CITY OF KELOWNA
MEMORANDUM

APPLICATION NO. DP08-0234

AT: 2955 Pandosy Street

PURPOSE: TO APPROVE A DEVELOPMENT PERMIT FOR THE FORM AND CHARACTER OF THE PROPOSED 4 STOREY, 39-UNIT MIXED-USE SUPPORTIVE HOUSING BUILDING

1 SITE PLAN
SCALE: 1/8"=1'-0"

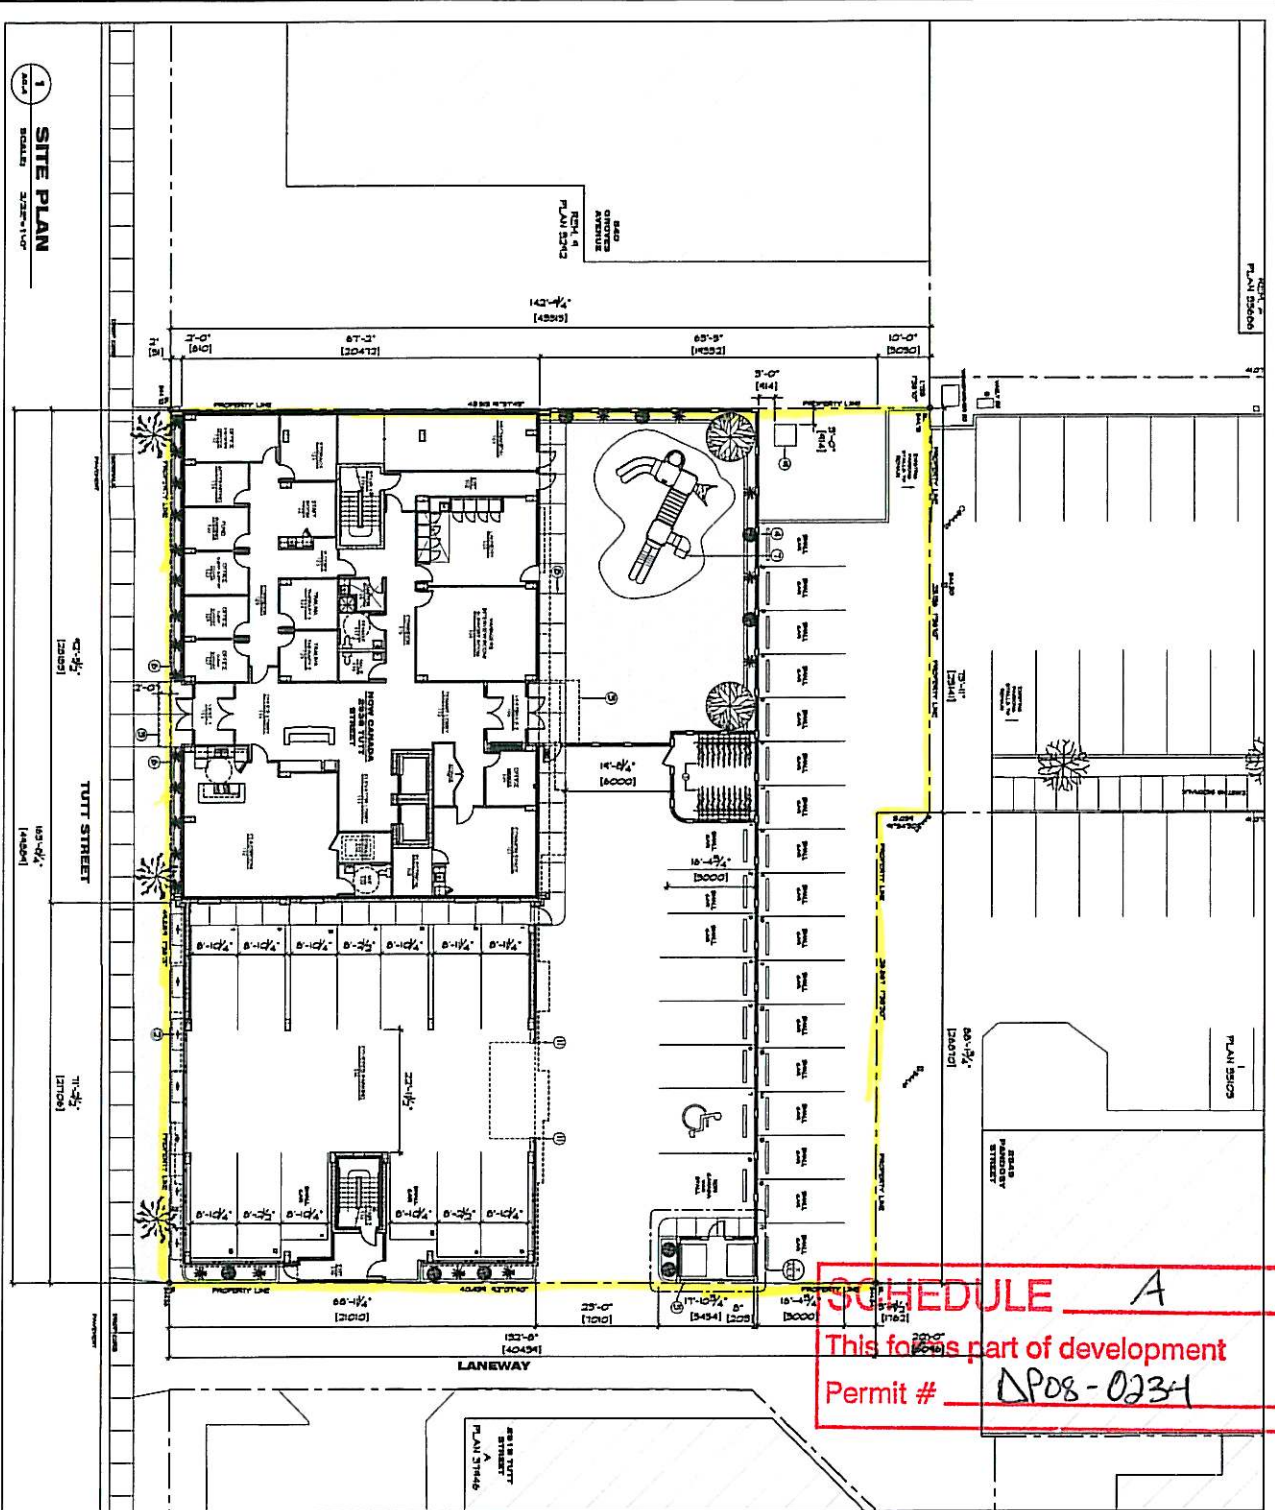
- (a) The site plan should illustrate the ability of vehicles to manoeuvre onto and off the site without requiring a reverse movement onto public roadways. If the development plan intends to accommodate larger vehicles, the site plan should be modified and illustrated accordingly.
- (b) A revised site access and egress design onto Pandosy Street and Tutt Street as well as the parking lot configuration must be submitted for approval by the City before issuance of a development Permit. This is required to guarantee that the requirements and the limitations of access and egress required by the City have been addressed to the City's satisfaction.

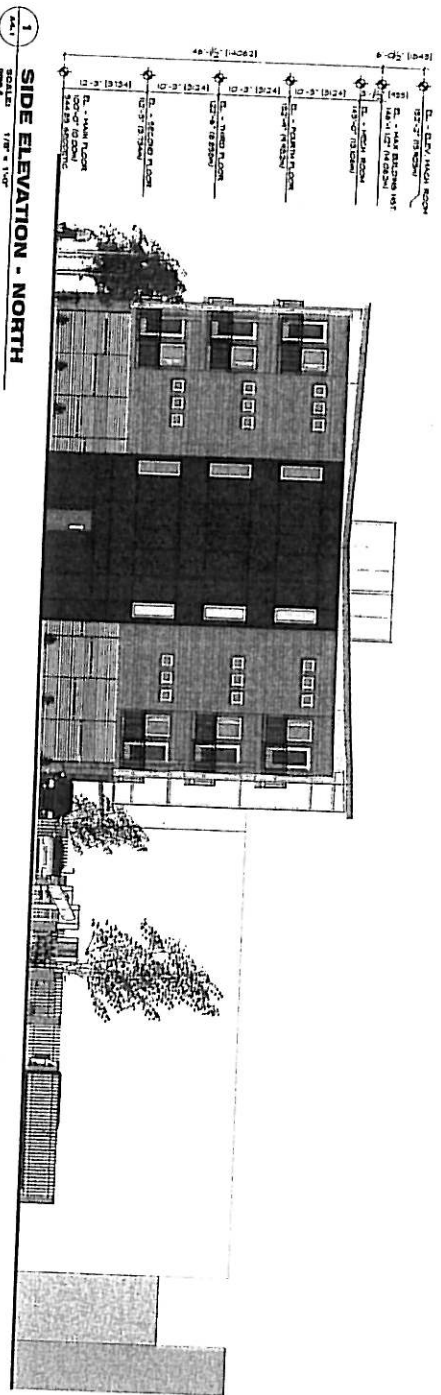
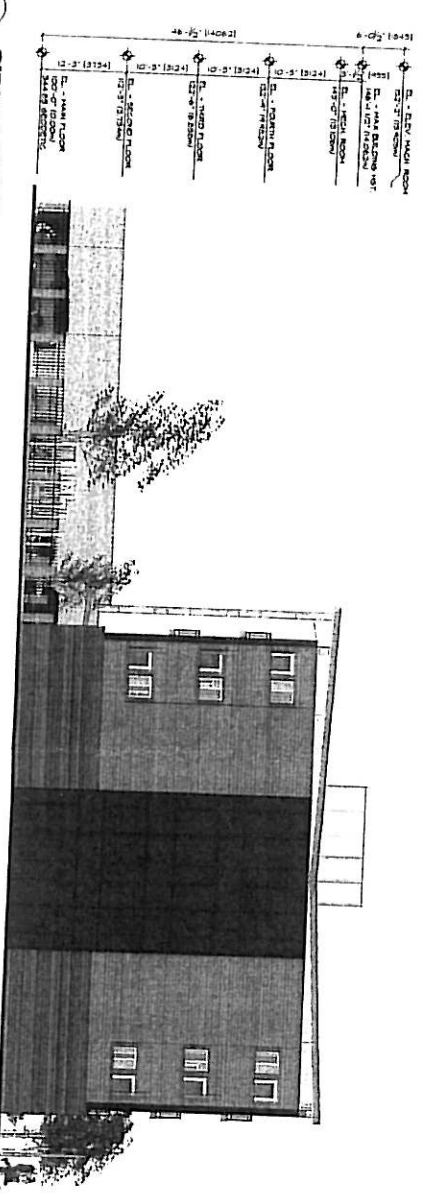
Door from stair shaft from residential floors (south elevation) to exit corridor to swing in direction of exit travel. Exit stair shaft from residential floors (north elevation) located in parkade must exit directly to exterior of building at laneway.
